Appendix J – Recommended Beehive Lane Car Park Layout

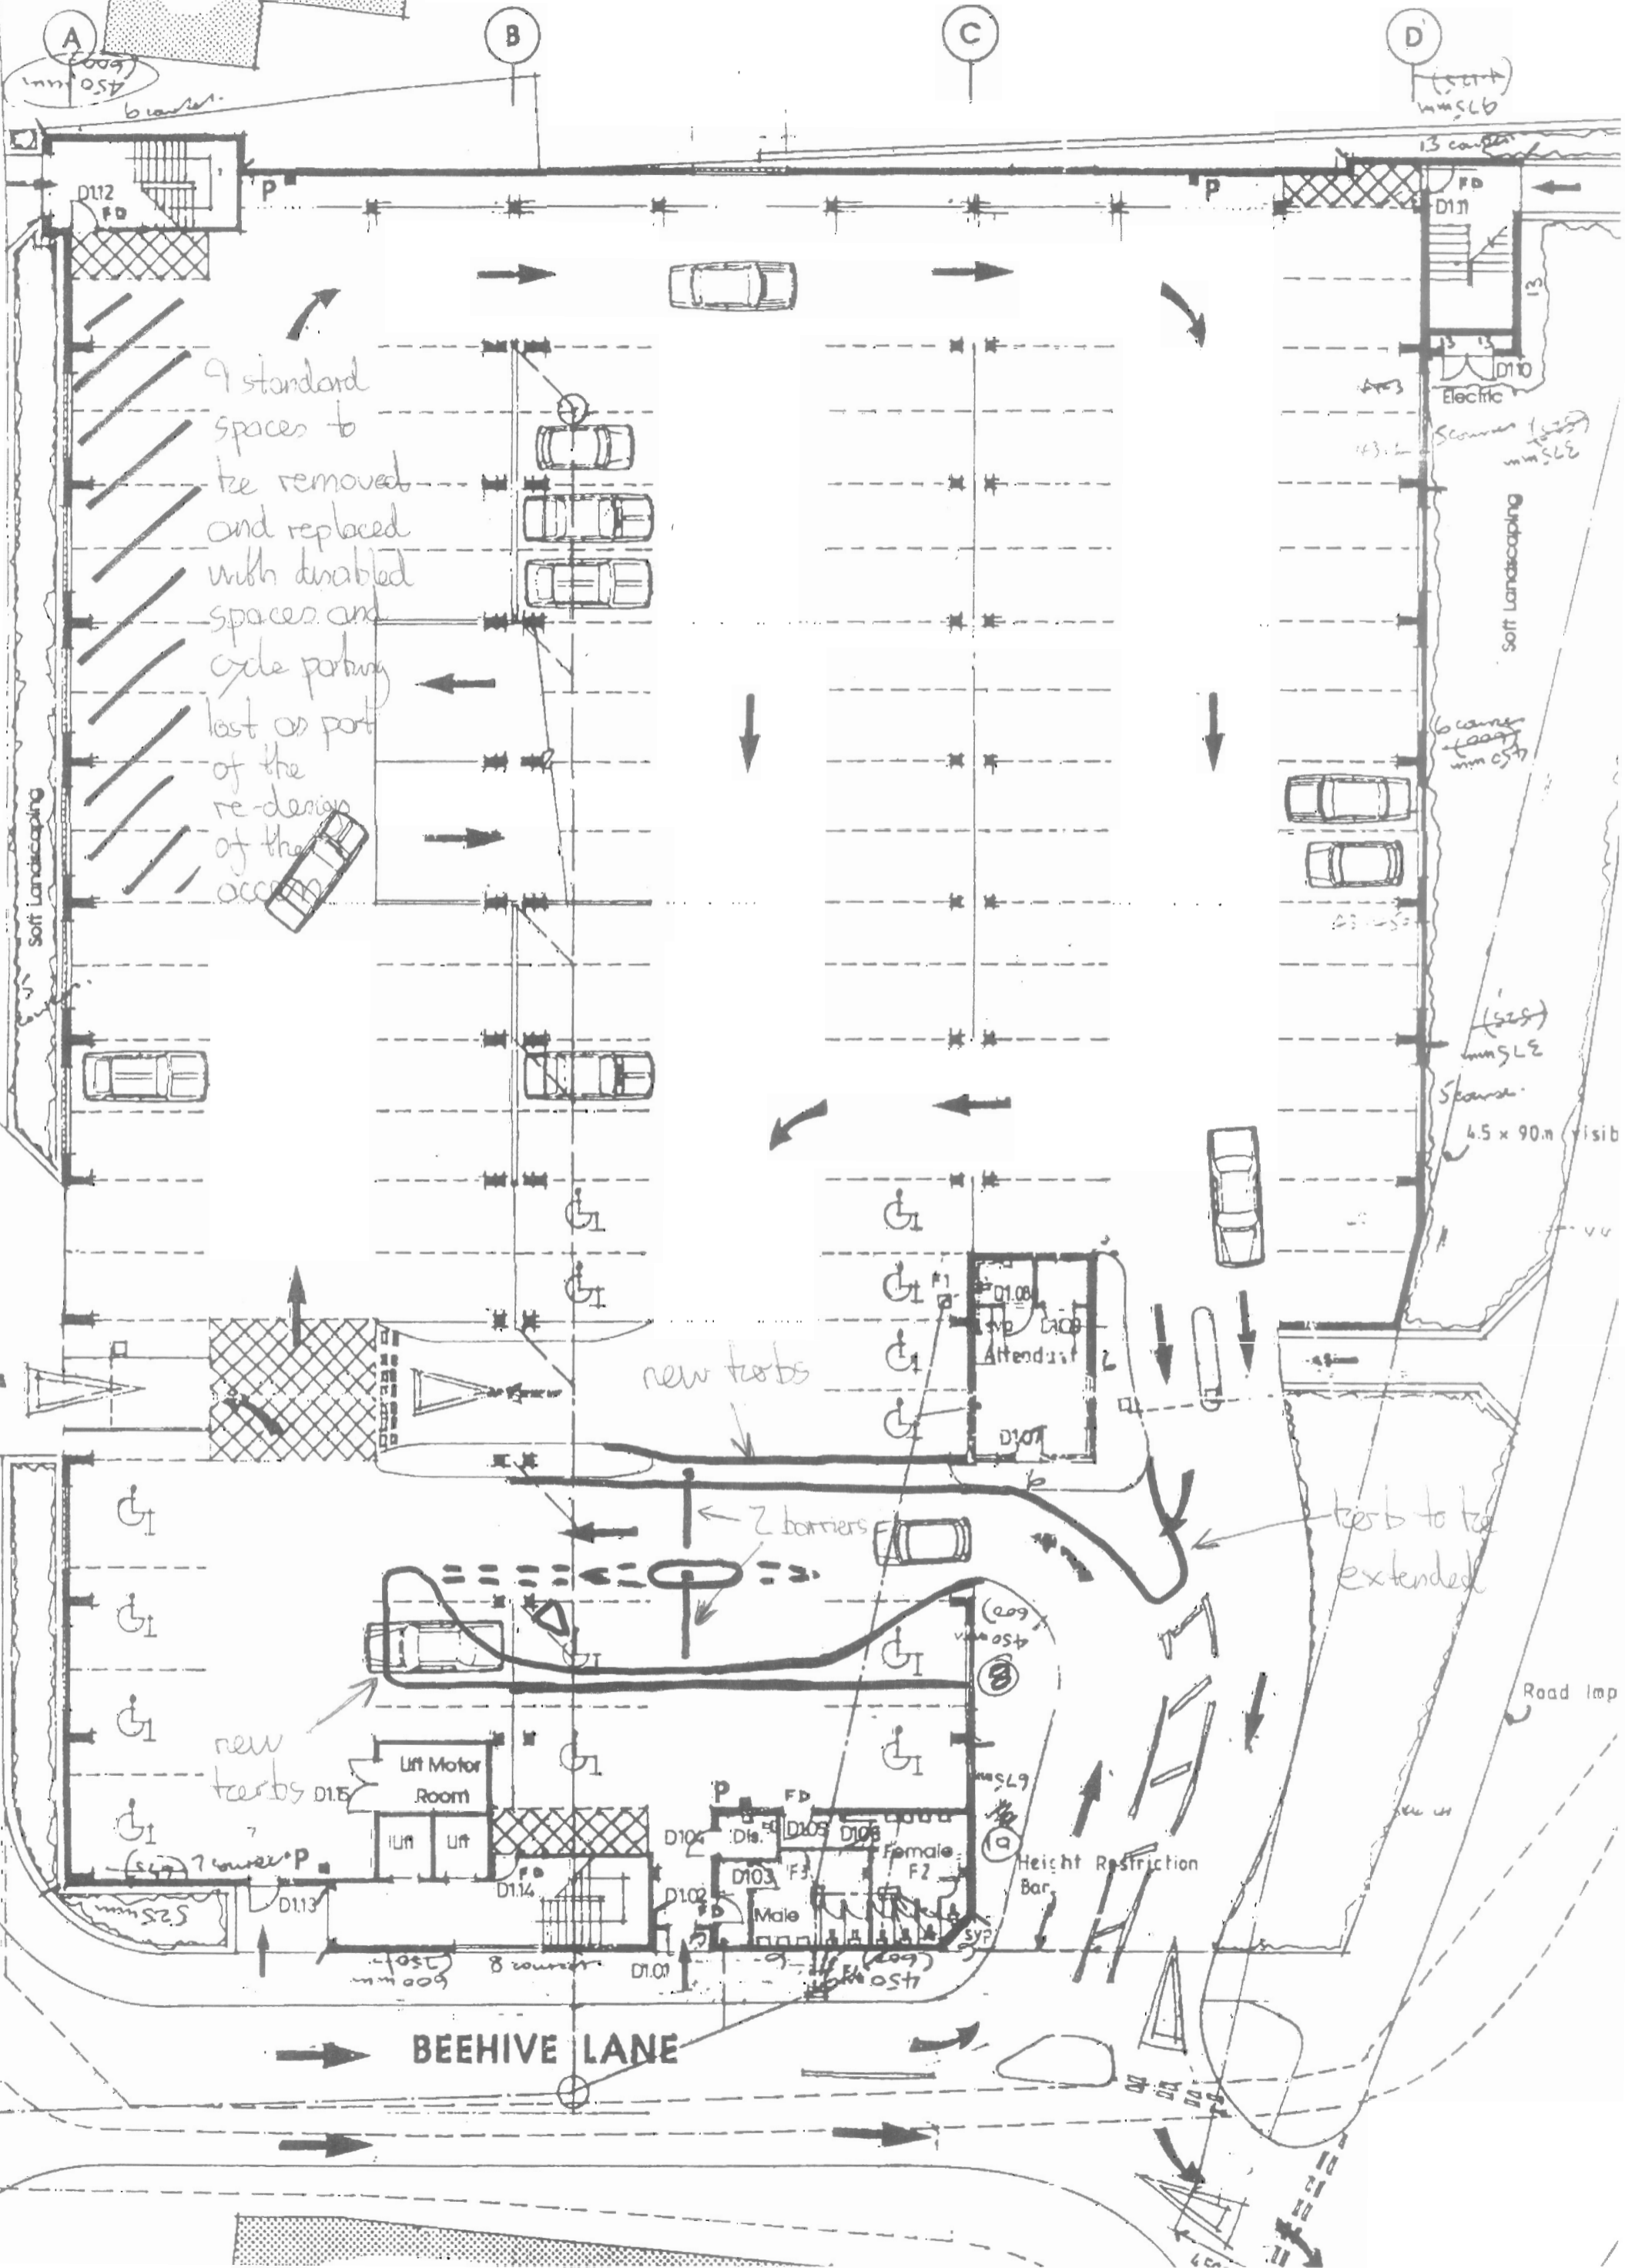
9 standard spaces to be removed and replaced with disabled spaces and cycle parking last as part of the re-design of the access

new kerbs

2 barriers

kerb to be extended

new kerbs

Height Restriction Bar
